APPLICATION NO.	FILING DATE	FIRST NAMED INVENTOR	ATTORNEY DOCKET NO.	CONFIRMATION NO.
10/658,256	09/10/2003	Tsung-I Yu	YUTS3014/EM	4016

Office Action Summary

DETAILED ACTION

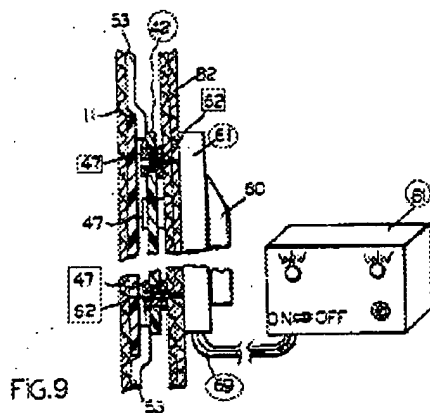
However, as the examiner had previously indicated, the selector switch 61, displayed in figure 7 and figure 9, is considered to be representative of **a component** of the electro-stimulating controller (see explanation below). The electro-stimulating controller does in fact possess buttons that enable it to be plugged in to the terminal plug receptacle 42 mounted on the garment 11. These buttons are depicted as 47 in figure 5 and as 62 in figure 7. The connection and mounting of the controller on the garment is displayed in figure 9, replicated below.

Furthermore, since the selector switch is connected to the pulse generator with a cable 69, which supplies desired electrical muscle-stimulating pulses from a generator 81" (col. 3, lines 58-59), the examiner considers both the selector switch and the pulse generator to be representative of the electro-stimulating controller. Since the electro-stimulating controller contains both the selector switch 61 **and** the pulse generator 81, facilitated by the connection of cable 69, the electro-stimulating controller inherently possesses an internal circuit (IC). Figure 9 also displays the ON/OFF button on the pulse generator 81.
